**TOWN OF HUDSON
PLANNING BOARD
PUBLIC MEETING
TOWN OF HUDSON, NH
JULY 24, 2013**

4 Candy Lane Site Plan

PLAN UNDER REVIEW ENTITLED: Non-Residential Site Plan 4 Candy Lane Map 101 Lot 027, Hudson, NH, prepared by Keach-Nordstrom Associates, Inc., dated: May 1, 2013, last revised July 12, 2013, consisting of Sheets 1 - 17 and Notes 1 – 31 (said plans are attached hereto).

Re: Town of Hudson Planning Board Review
4 Candy Lane Site Plan, 4 Candy Lane
Tax Map 101, Lot 27, PO #1350-175
CLD Reference No. 03-0249.1270

DATE: MAY 1, 2013 SCALE: 1" = 30'
PROJECT NO: 13-0214-1 SHEET 9 OF 17

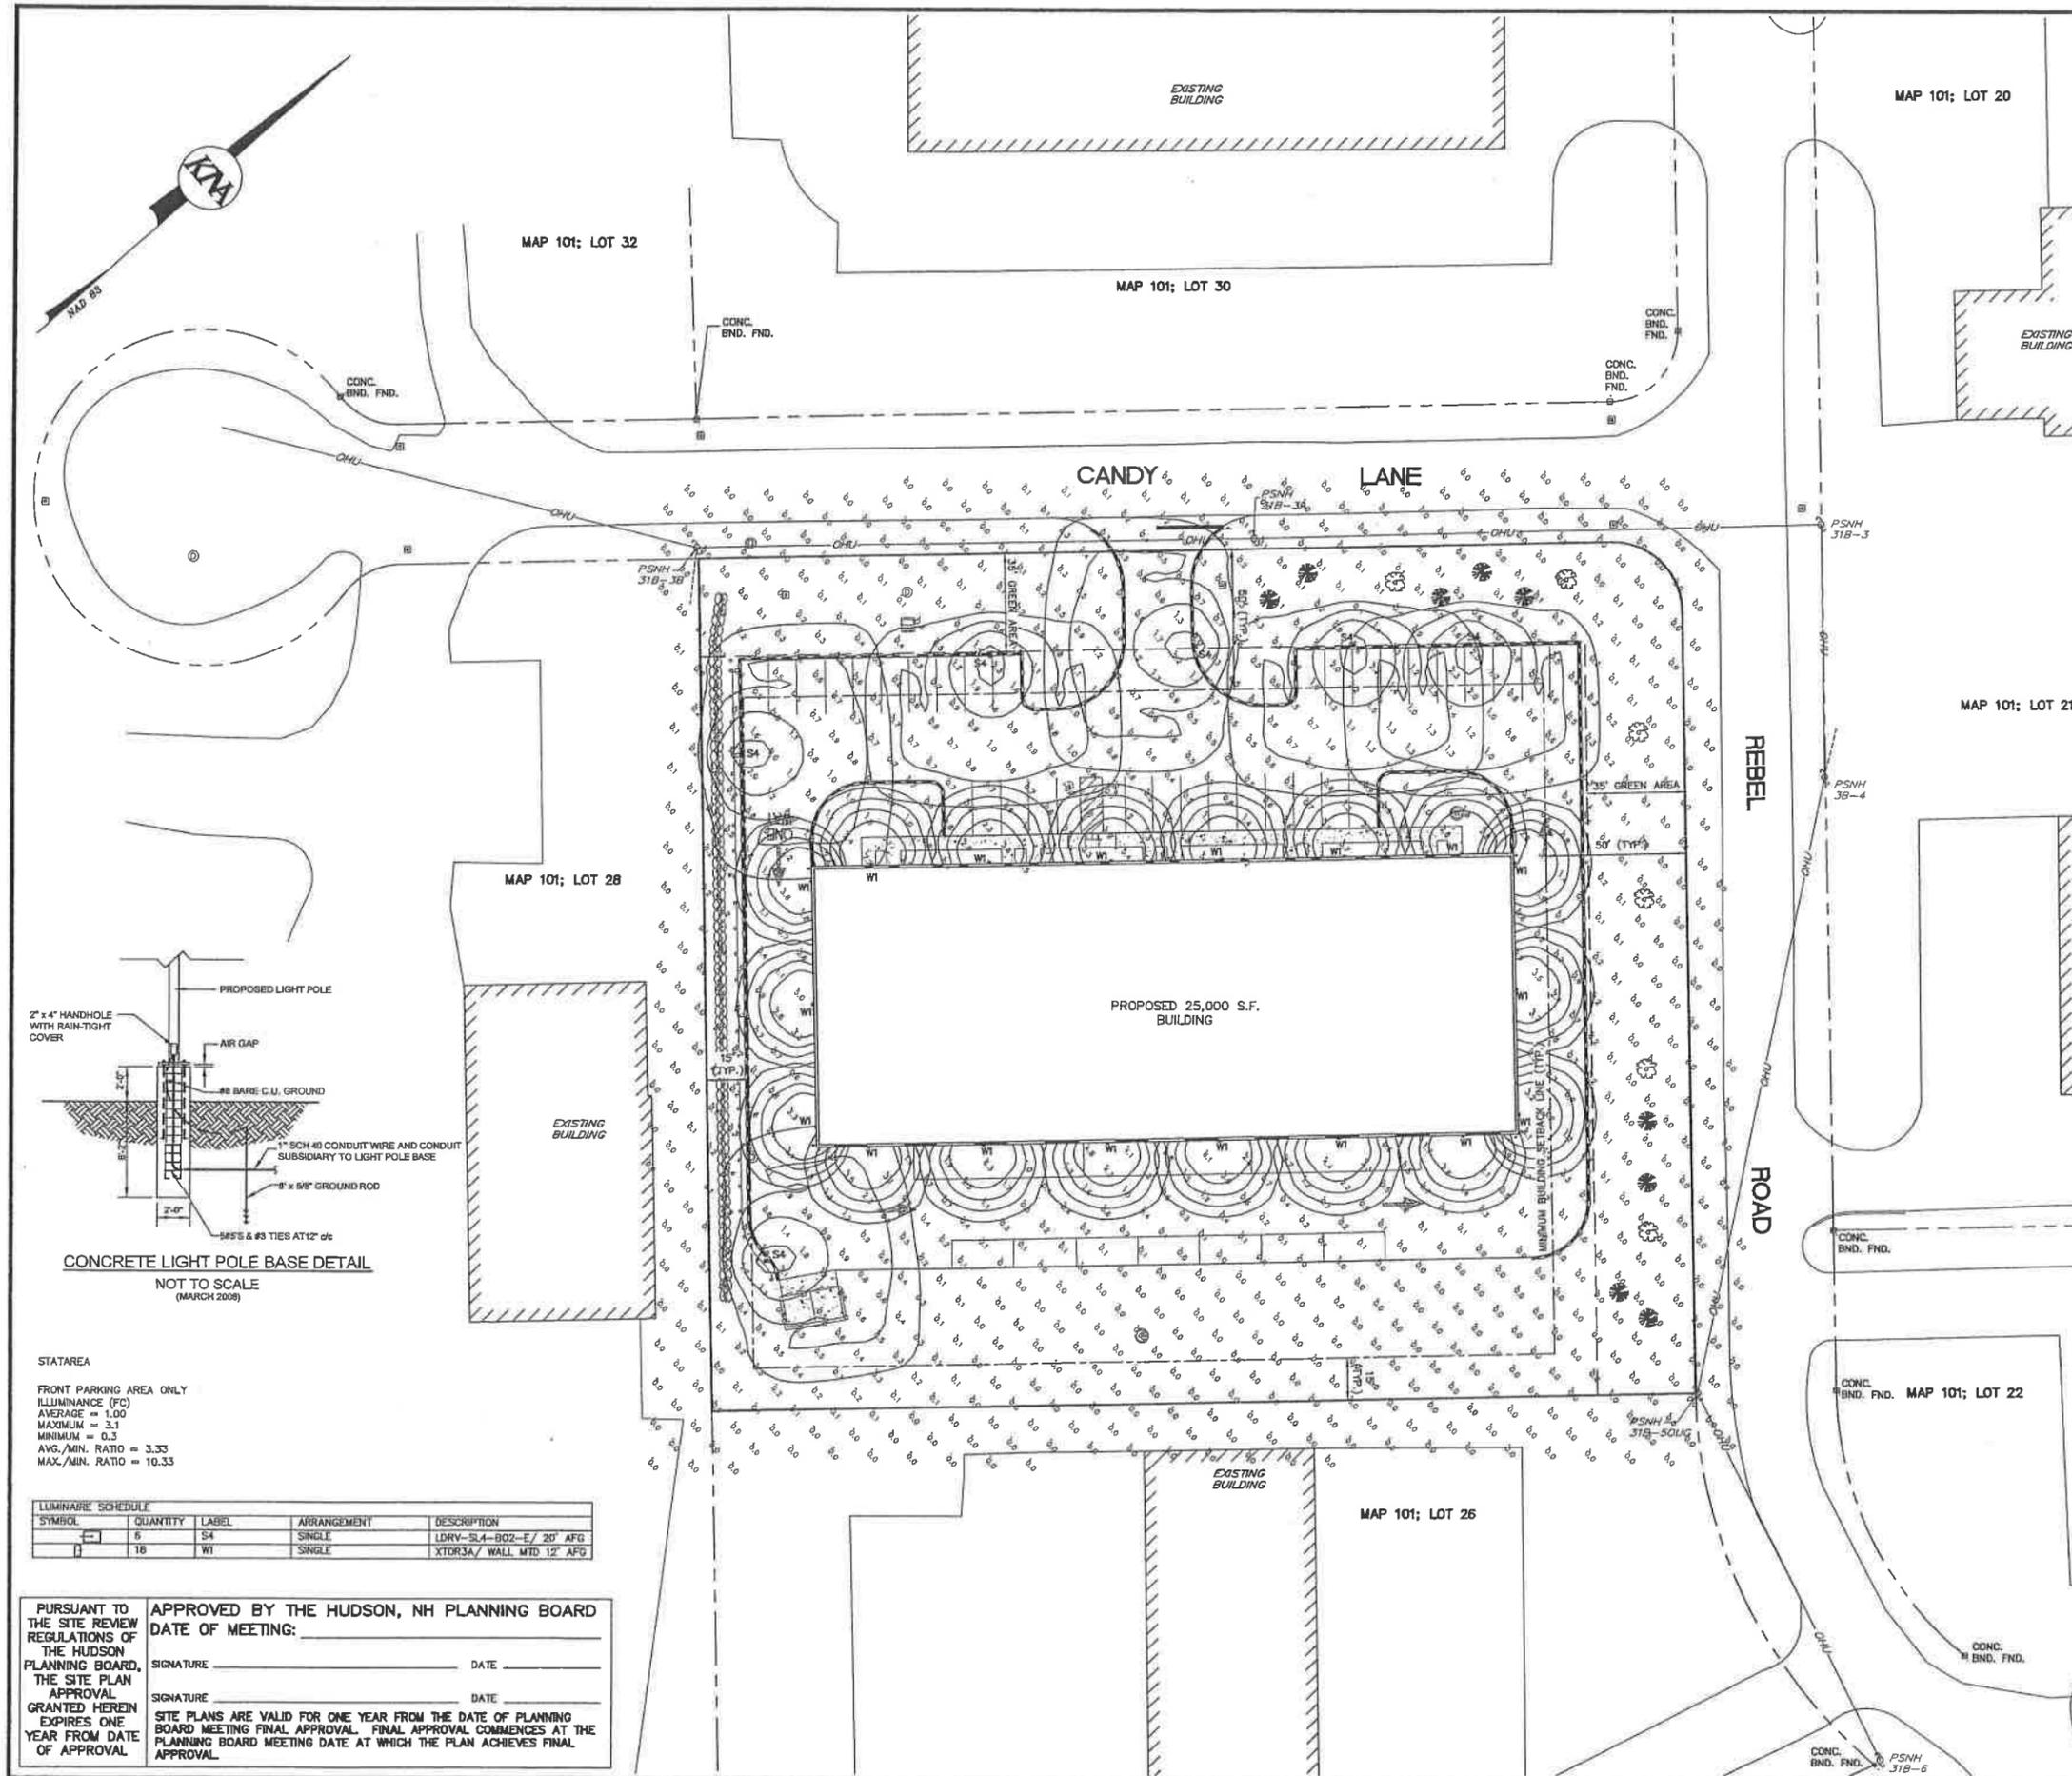
As cited in Keach-Nordstrom’s response letter, except for CLD’s pending traffic review of GPI’s Traffic Impact Assessment (“D”), the latter party’s outstanding issues have been resolved, and reflected as such, in the attached revised Site Plans. These issues include: Site Plan and Driveway review codes, Utility, Drainage & Stormwater Management improvements, together with Landscaping, Status of State and Local Permits and Comments regarding HFD’s recommendation (“E”). Note: one additional site feature, exterior light, is depicted on Sheet 9 of 17 of the attached Plans.

- 6) Onsite landscaping shall be provided for in accordance with the plant and tree species specified on Sheet 9 of 17 of the Plan.
- 7) Construction activities on the site shall be limited to between 7:00 A.M. and 7:00 P.M. Monday through Saturday. No construction activities shall occur on Sunday.

REDI-ROCK RETAINING WALL SECTION
NOT TO SCALE

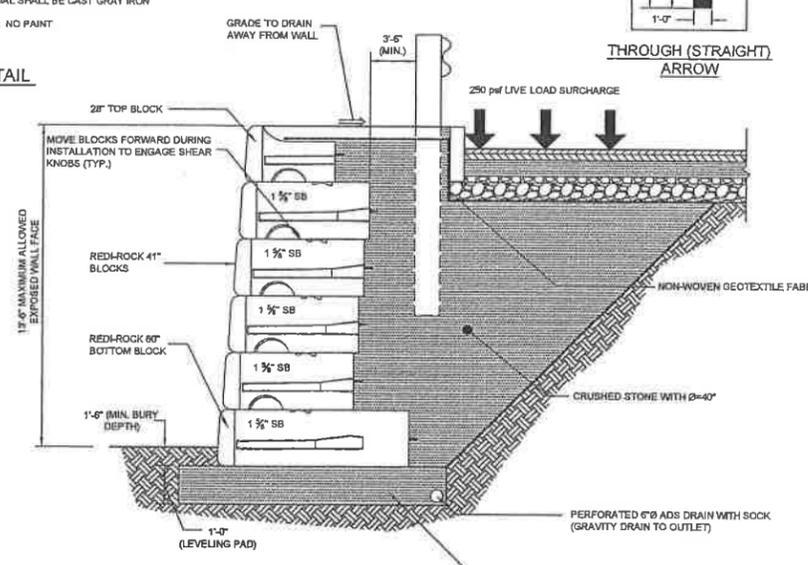
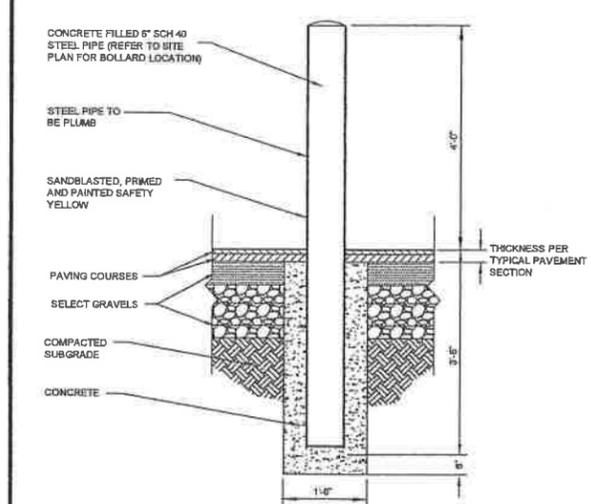
A detail of the proposed redi rock retaining wall has been added to the plan set (sheet 12 of 17). Final design of the wall be prepared by a structural engineer based on site geotechnical testing results of the parent soil.

- NOTES:**
- PRIOR TO THE CONSTRUCTION OF THIS RETAINING WALL, A STRUCTURAL ENGINEER SHALL PREPARE A FINAL DESIGN USING THE ACTUAL CONDITIONS FOUND AT THE SITE.
 - THIS DETAIL IS SCHEMATIC ONLY AND IS BASED ON A NATIVE SOIL THAT IS SILTY SAND, CLAYEY SAND WITH AN INTERNAL FRICTION ANGLE OF 28°.
 - ALL REDI-ROCK SPECIFICATIONS SHALL BE FOLLOWED.
 - REDI-ROCK RETAINING WALL MAY BE SUBSTITUTED FOR AN EQUAL RETAINING WALL PRODUCT/SYSTEM. APPROVAL FROM STRUCTURAL ENGINEER IS REQUIRED.
